**Re: Cork City Council - Lehenaghmore Roads Improvement Scheme Acquisition Order
No. 2 of 2022**

**Lehenaghmore Road Improvement Scheme
Response to Submissions**

Mr. Frank Urell – CPO Plot Ref. 94

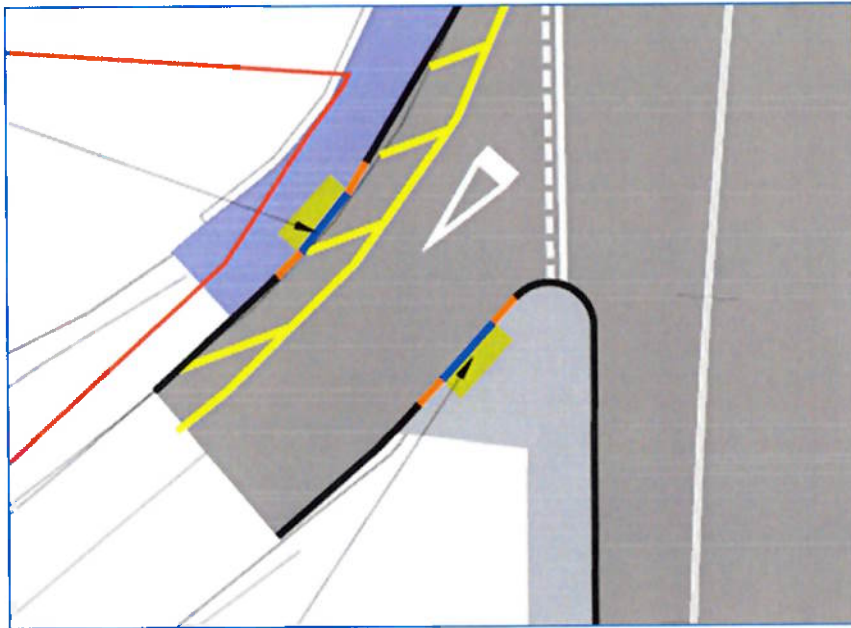
3. Suggestion of possible interference with parking area on lands of Mr. Urell

Response: The proposed scheme will not interfere with the 'major asset in the parking area'. Mr. Urell's lands inside (and including) his palisade fence are not now being acquired. All of the works are being undertaken on the public road side of the existing boundary.
